# HISTORIC AND DESIGN REVIEW COMMISSION July 07, 2021

HDRC CASE NO: 2021-309

**COMMON NAME:** 515 N PALMETTO, 519 N PALMETTO

**TYPE OF WORK:** Landscaping amendments, porch railing installation, fencing, walkway design

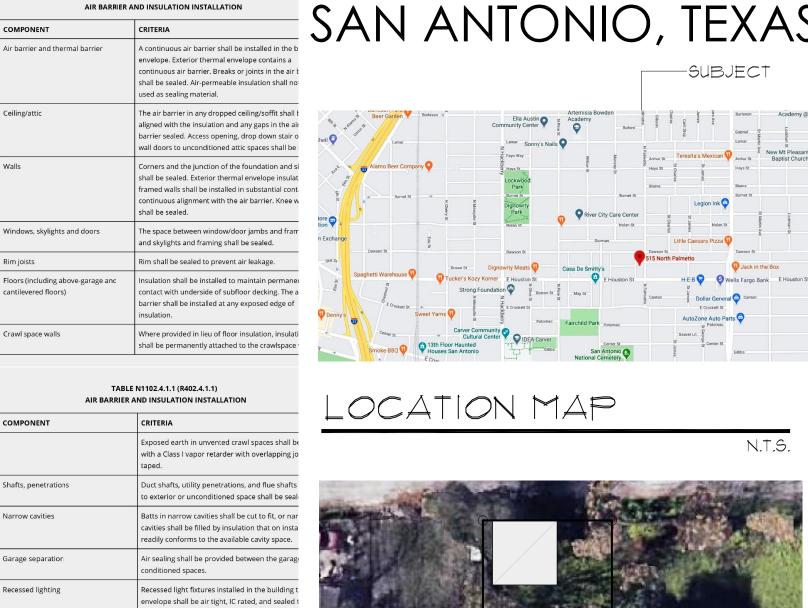
- c. PORCH RAILING The applicant is requesting approval to install porch railing at each house, 511, 515, and 519 N Palmetto. Generally, staff finds the installation of porch railing to be appropriate; however, it should be designed in a manner that is architecturally appropriate with both the design of each house and the Historic District. Staff has included an example of architecturally appropriate porch railing in the exhibits.

- 1. Staff does recommends approval of item #1, the installation of front porch railing as submitted. Staff recommends the applicant install porch railing with an appropriate profile, as noted in finding c. A detailed drawing has been included in the exhibits for reference.
